Access Compliance Report

Public Rights-of-Way

(Curb Ramps)

Intersection ID: 11453	Main Street: FLORIDA_AV	Cross Street: MATHESON_AV	Location: NE
ADA ID: 1B20C0090895	Ramp Type: Perp	Initial Pass/Fail: Fail	Overall Compliance: No
Codes/Mitigation Info/Possible Solution			Severity Score: 35
			Field Measurements/Component Compliance

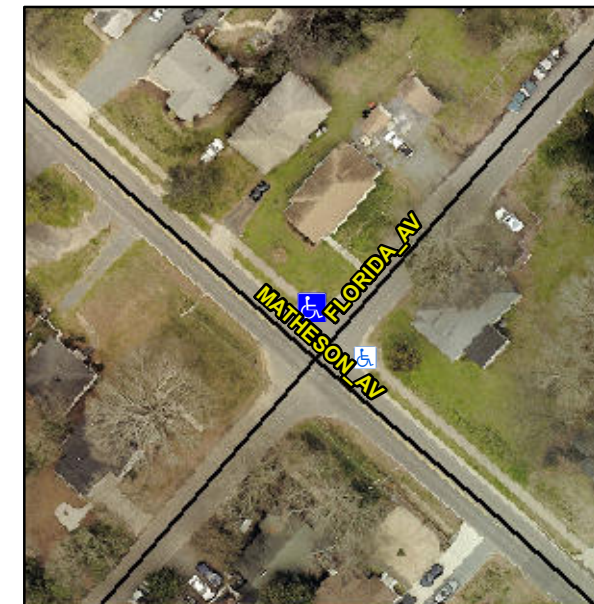
Not Found, R304.5.1, R304.2.2, R304.5.3

Compliance	Description	Data	Compliance	Description	Data
N/A	Ramp Length (in)	48.5	No	Ramp Slope (%)	12.3
No	Ramp Width (in)	47.5	No	Ramp XSlope (%)	3.5
N/A	Flare Type LT	N/A	N/A	Flare Type RT	N/A
N/A	Flare Slope LT (%)	N/A	N/A	Flare Slope RT (%)	N/A
N/A	Flare Traversable LT?	N/A	N/A	Flare Traversable RT?	N/A
N/A	Landing Length (in)	N/A	N/A	DWS Provided?	N/A
N/A	Landing Width (in)	N/A	N/A	DWS Contrast?	N/A
N/A	Landing Slope (%)	N/A	N/A	DWS Length (in)	N/A
N/A	Landing X Slope (%)	N/A	N/A	DWS Full Width?	N/A
N/A	Landing Curb? (Y/N)	N/A	N/A	DWS Offset (in)	N/A
N/A	Shared Landing?	N/A			
N/A	Gutter Ponding?	N/A	N/A	Gutter Slope (%)	N/A
N/A	Gutter Lip Ht (in)	N/A	N/A	Gutter X Slope (%)	N/A
N/A	Painted X Walk1?	No	N/A	Painted X Walk2?	N/A
	X Walk 1 Direction	To SE		X Walk 2 Direction	N/A
N/A	X Walk 1 Width (in)	N/A	N/A	X Walk 2 Width (in)	N/A
	X Walk 1 Slope (%)	0.5		X Walk 2 Slope (%)	N/A
	X Walk 1 X Slope (%)	5.6		X Walk 2 X Slope (%)	N/A

Remove & Replace Entire Ramp.
